Solicitation Addendum

Addendum No.: 2
Solicitation No.: 18-TA002764JP
Project No.: 6086160
Solicitation Title: Rye Road Functional Improvements and Master Lift Station
Addendum Date: June 11, 2018
Procurement Contact: Joe Pretorius, johannes.pretorius@mymanatee.org

STRUCTURAL REHABILITATION EYE ROAD BRIDGES @ MULL CREEK BRIDGES #134025 & #134026

RYE ROAD BRIDGES
OVER MILL CREEK
STRUCTURAL REHABILITATION

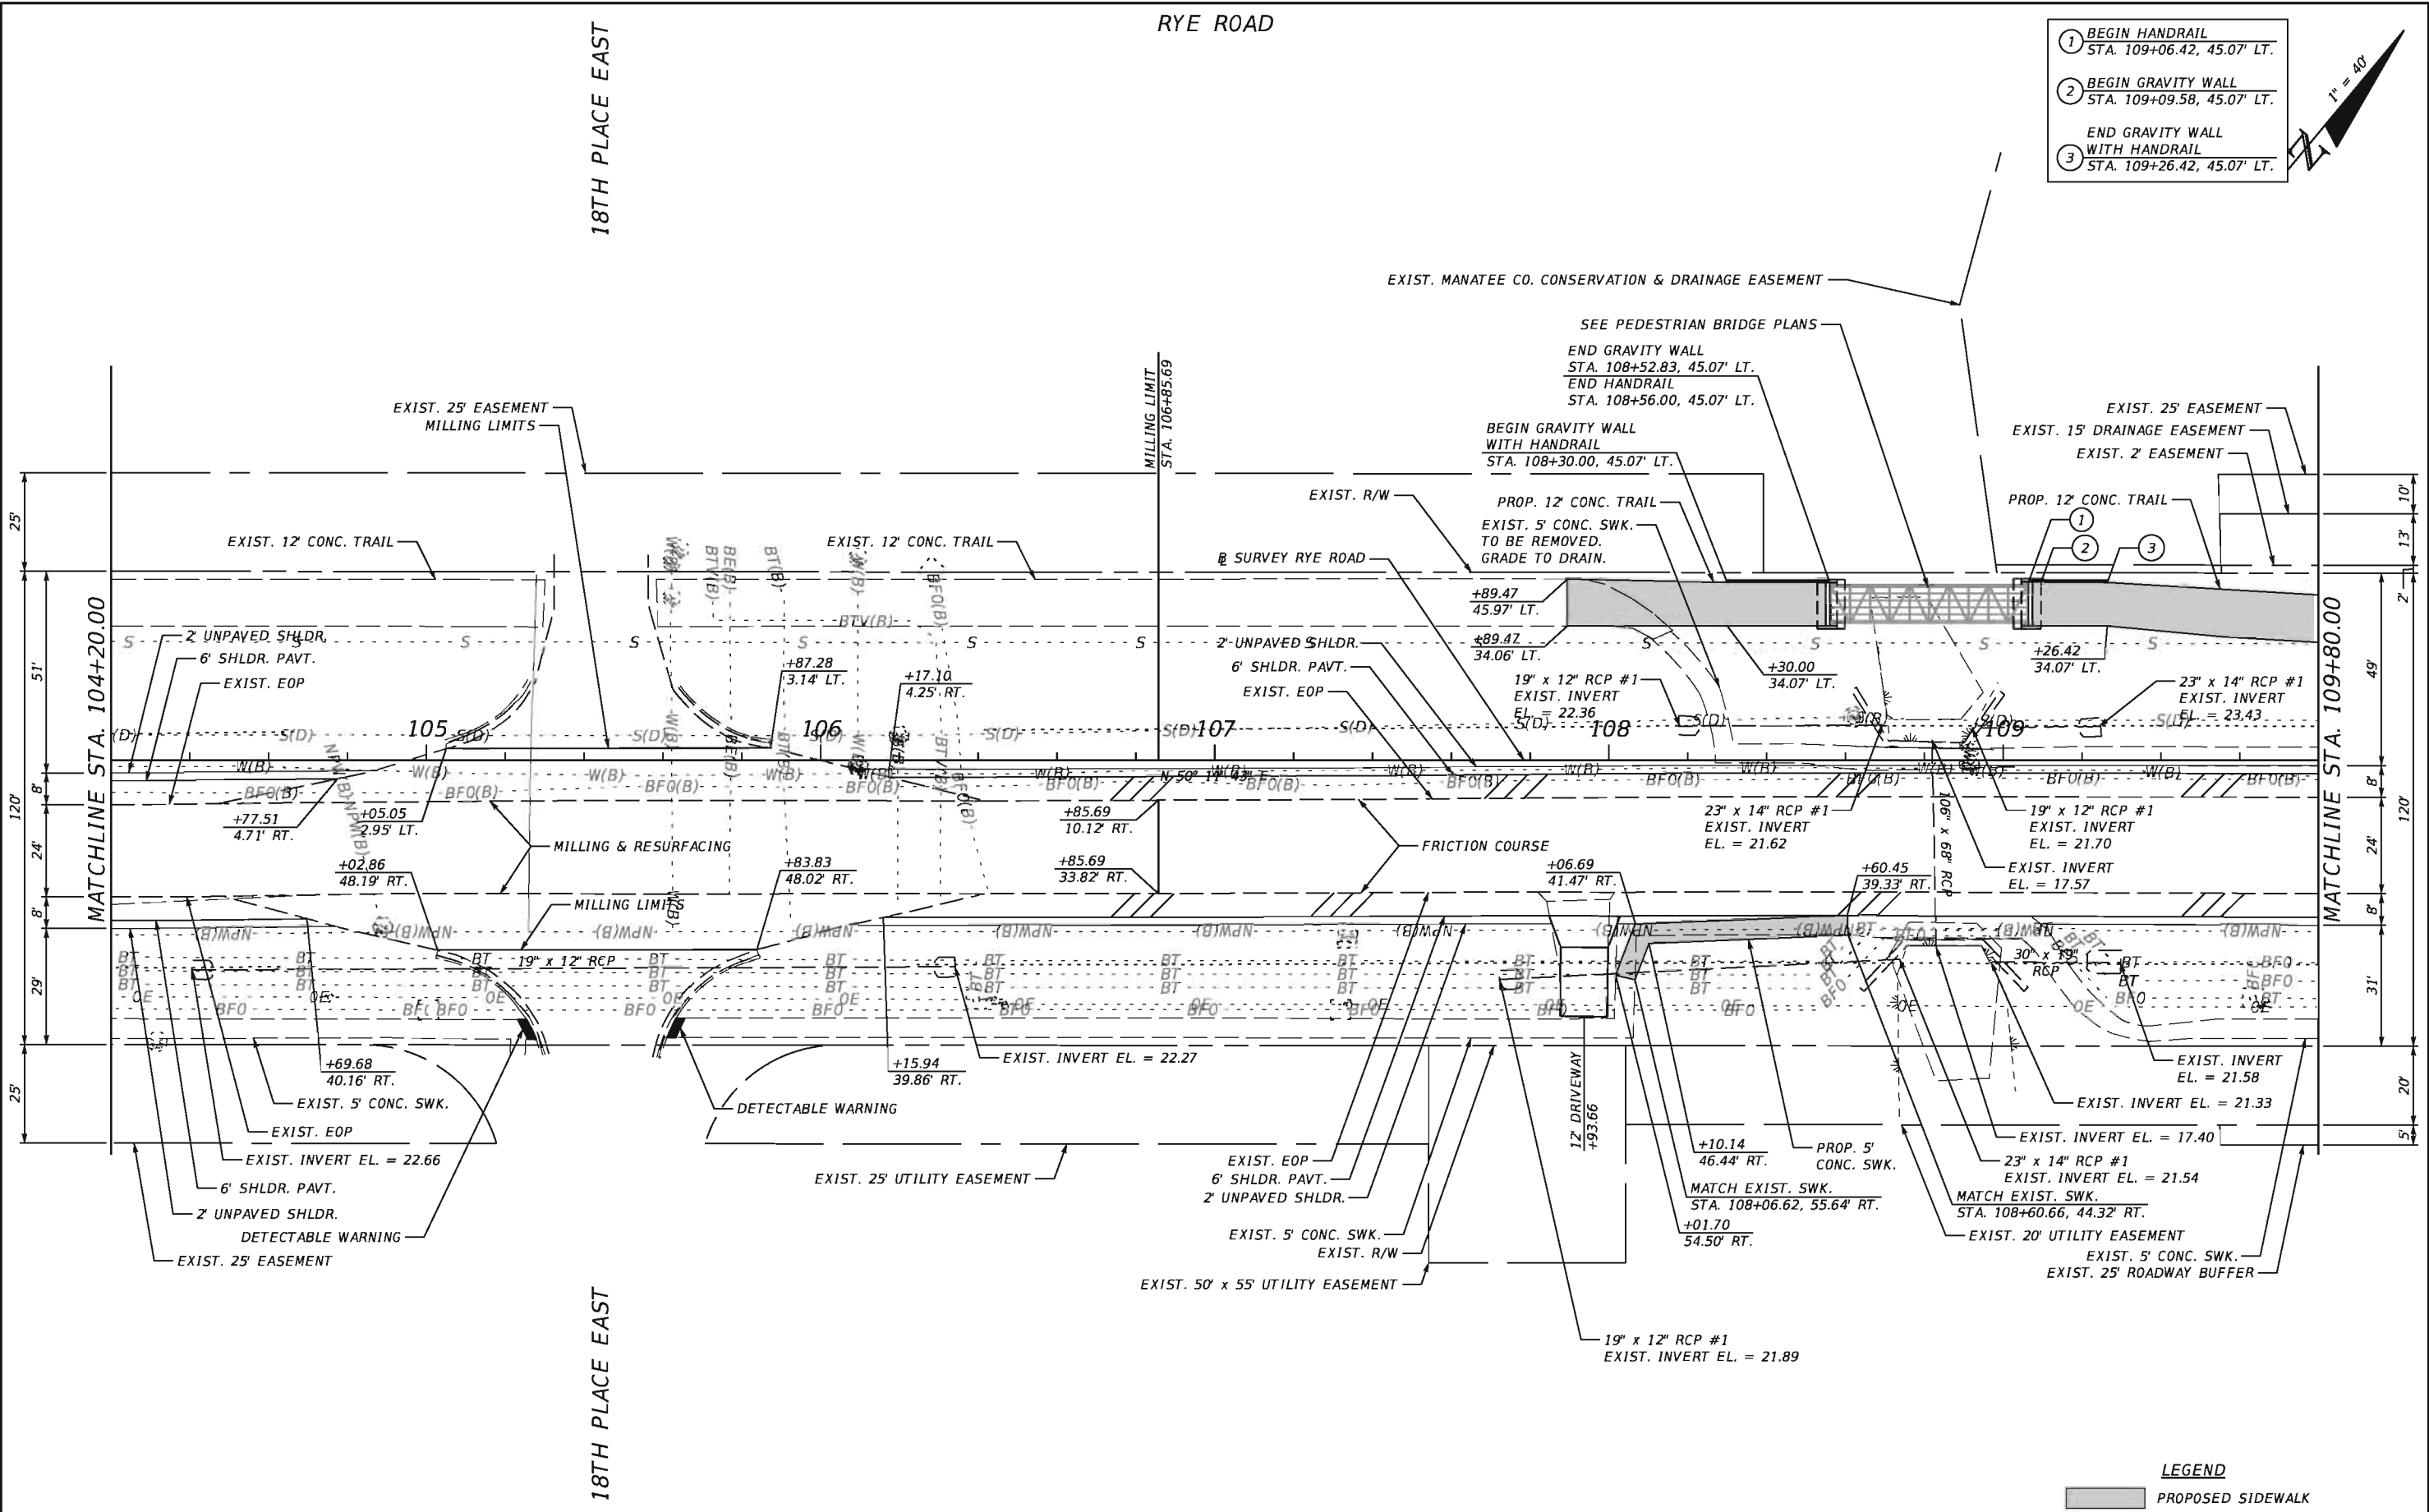
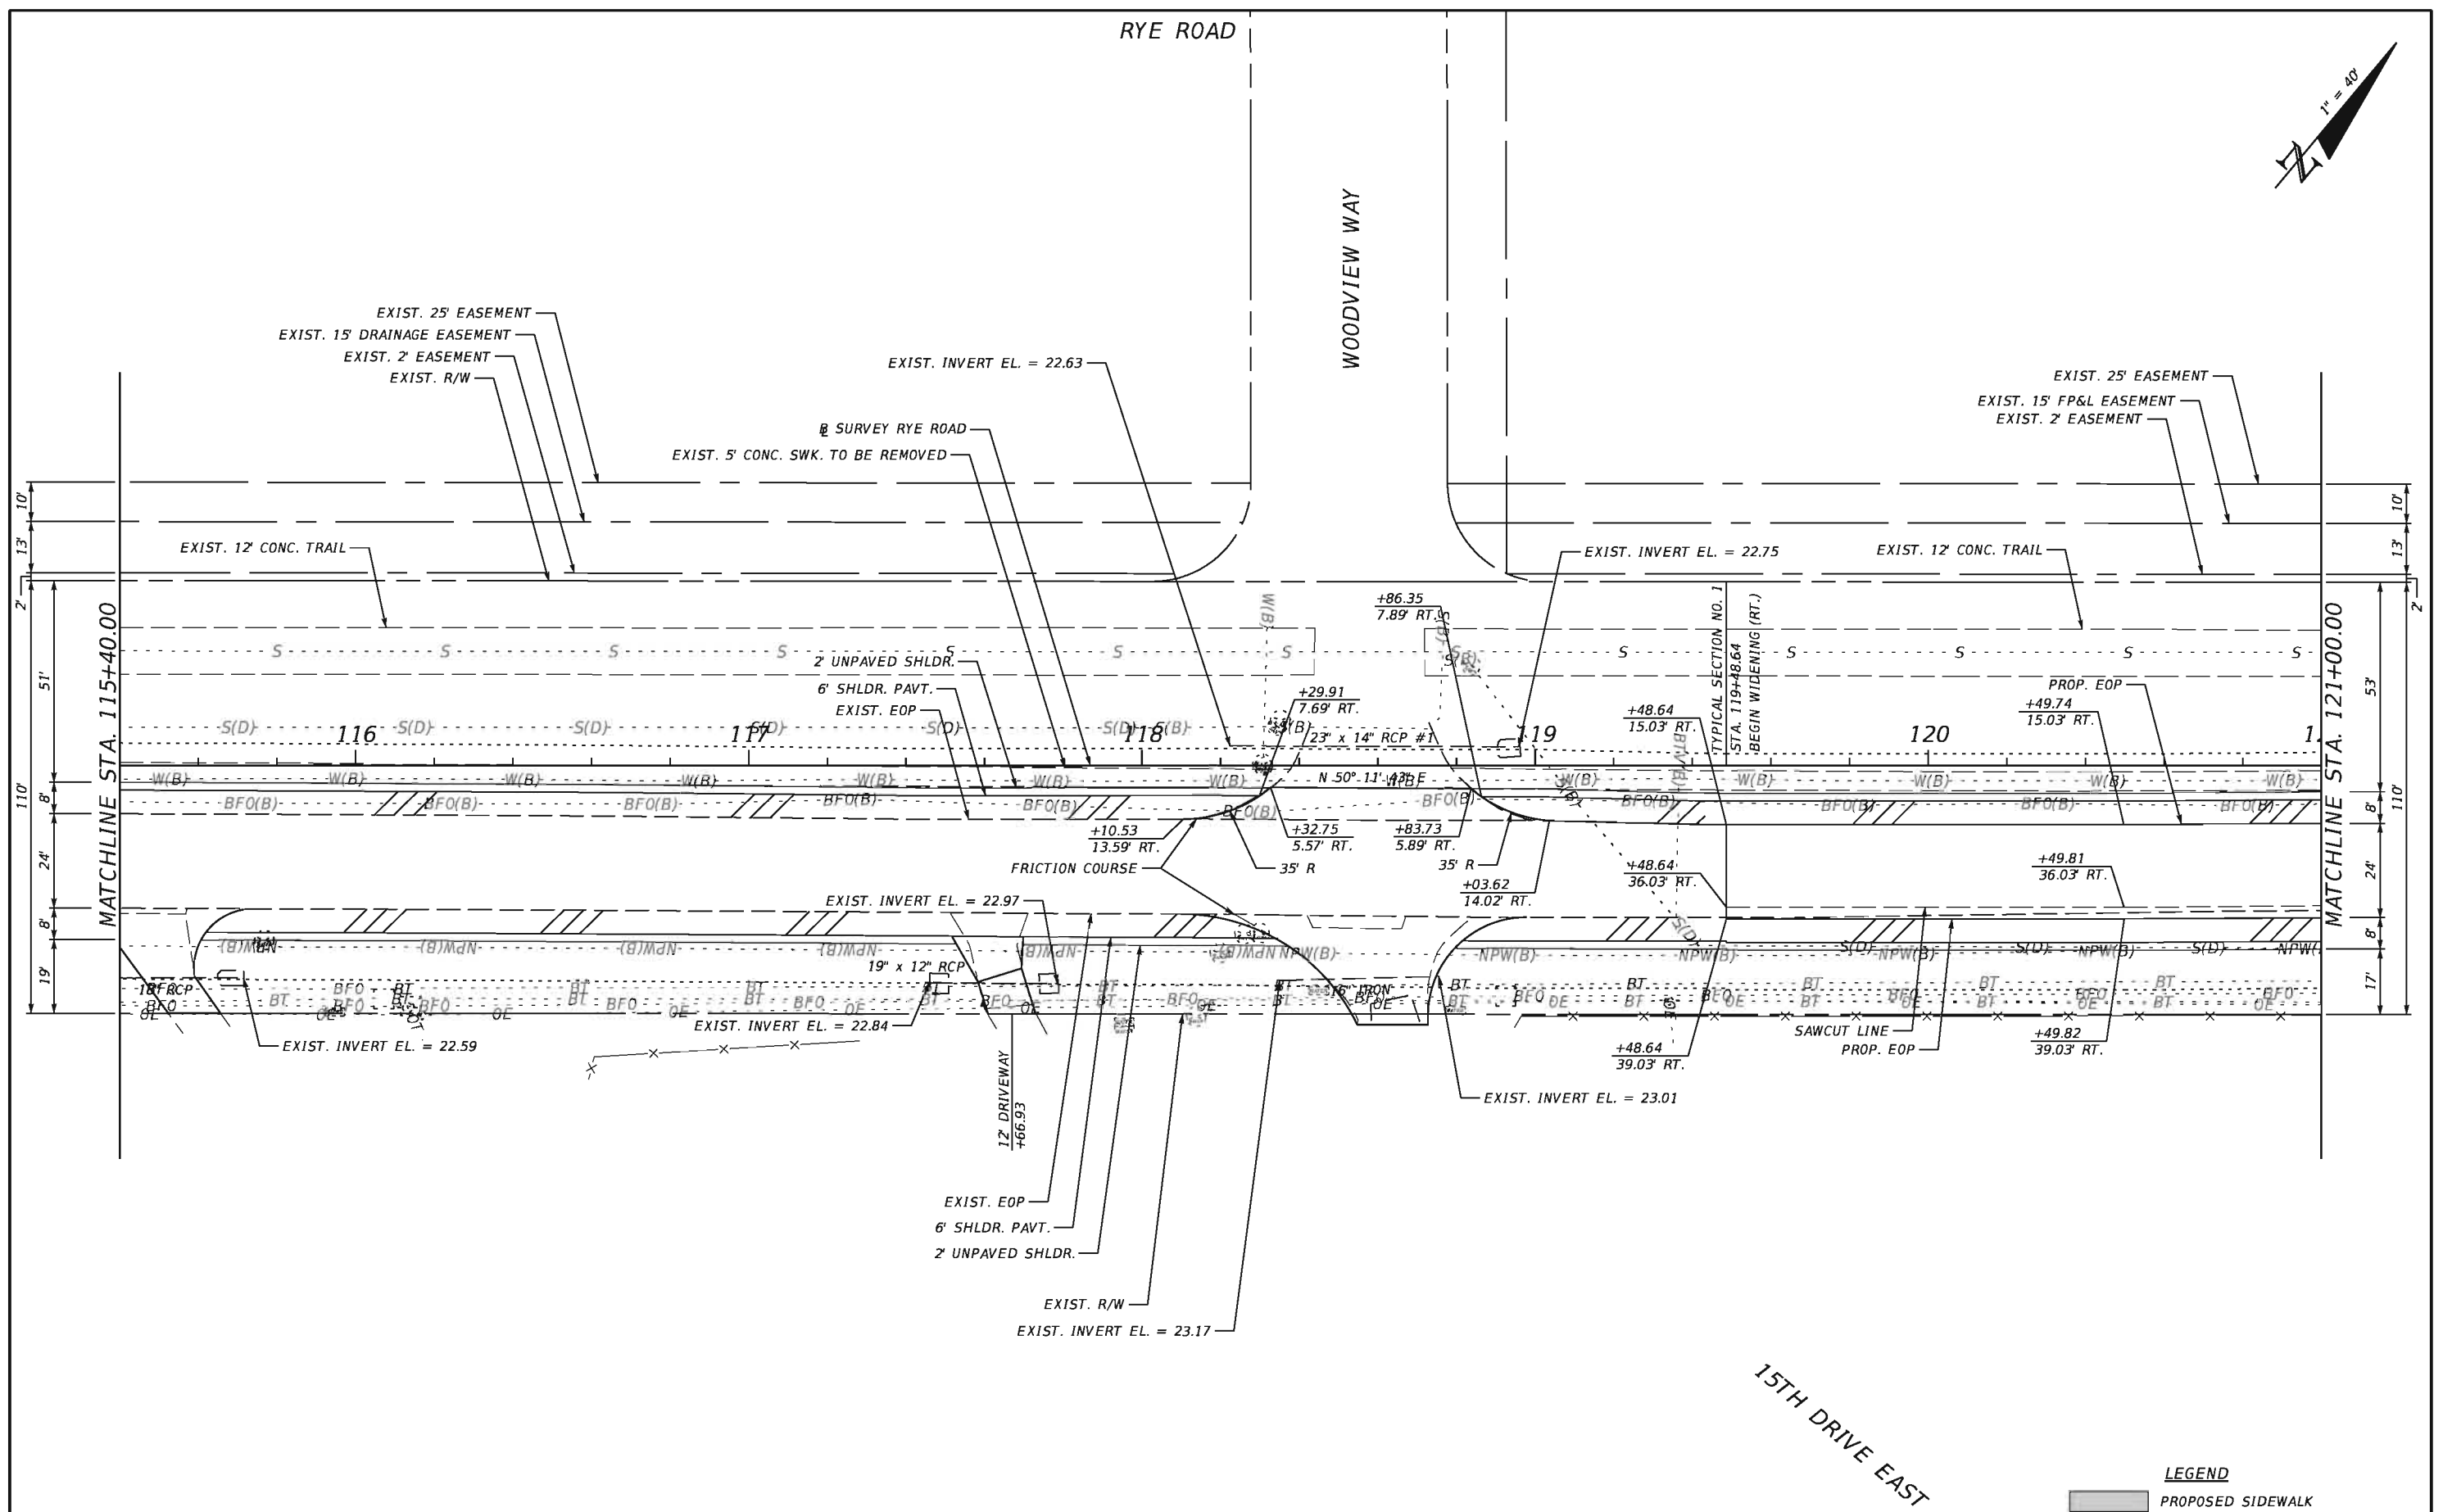
3. Sheet No. 9 - Roadway Plan (1) – Existing pipe sizes added [Question 18]
4. Sheet No. 10 - Roadway Plan (2) – Existing pipe sizes added [Question 18]

Q18. Referencing the General Notes, note #10 states, "All existing drainage structures, underdrain systems, ditches and ponds are to remain unless otherwise noted". There are no call outs for any of the existing drainage pipe to be removed where it appears that the pipe should be removed. How do we determine what is to be removed and what is not? Please clarify.

R18. Where new sidewalk construction / excavation impacts existing drainage pipes, the intent is to remove the existing pipes. Removal callout notes have been added to the plans per this Addendum No. 2.

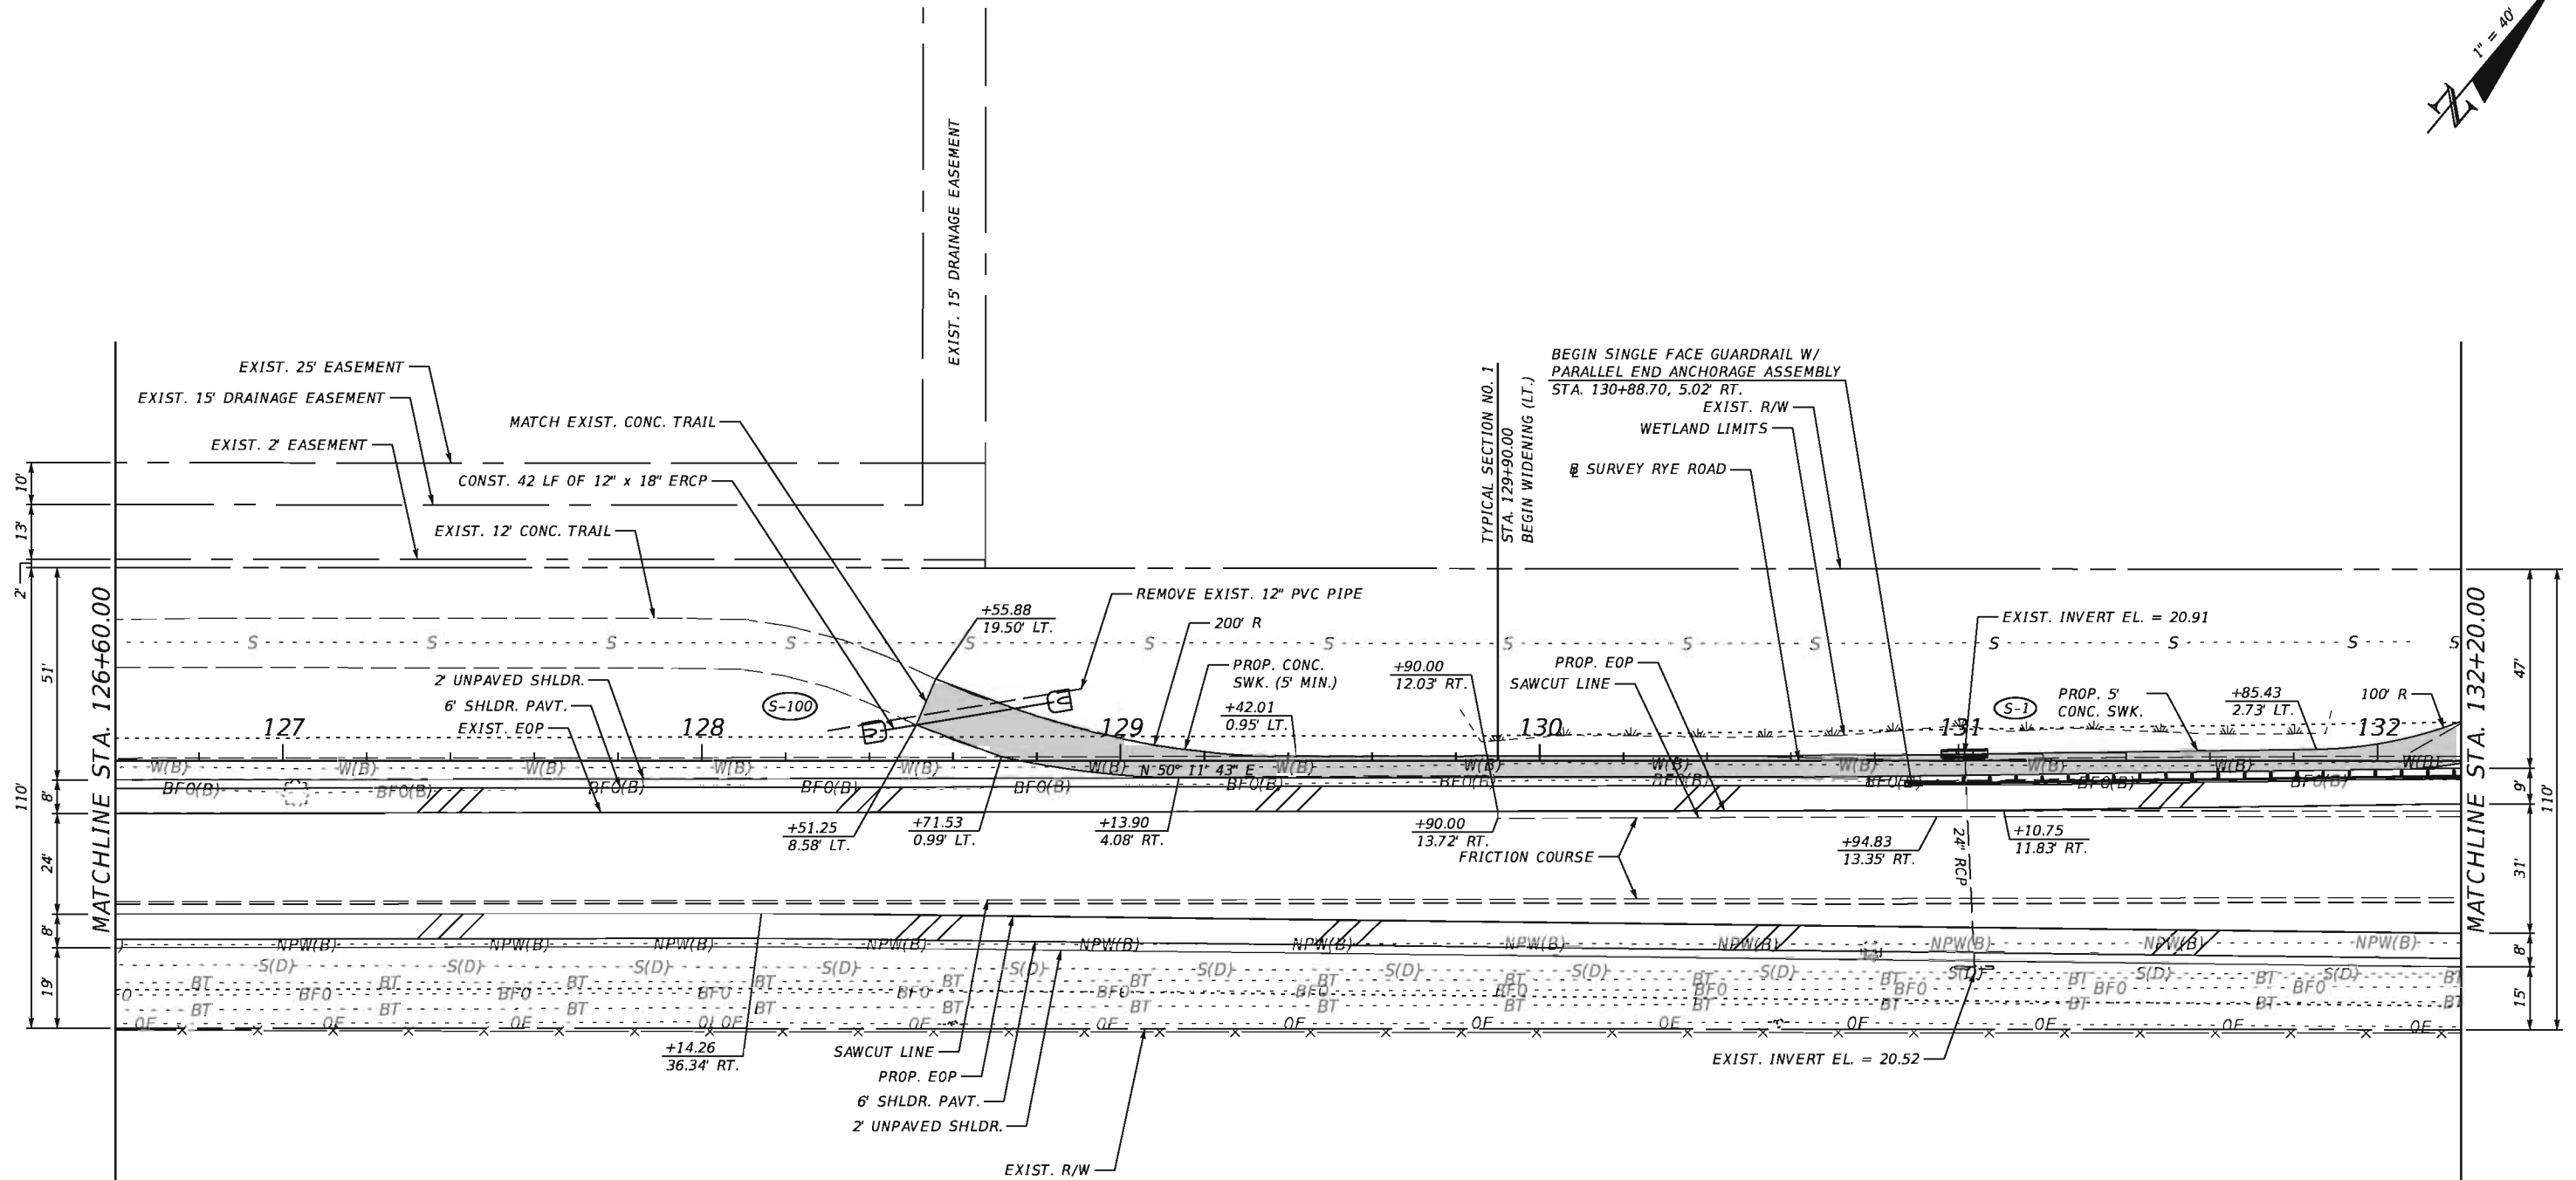
7. Sheet No. 13 - Roadway Plan (5) – Existing pipe sizes added [Question 18]
8. Sheet No. 14 - Roadway Plan (6) – Existing pipe sizes added; removal of existing pipe added [Question 18]
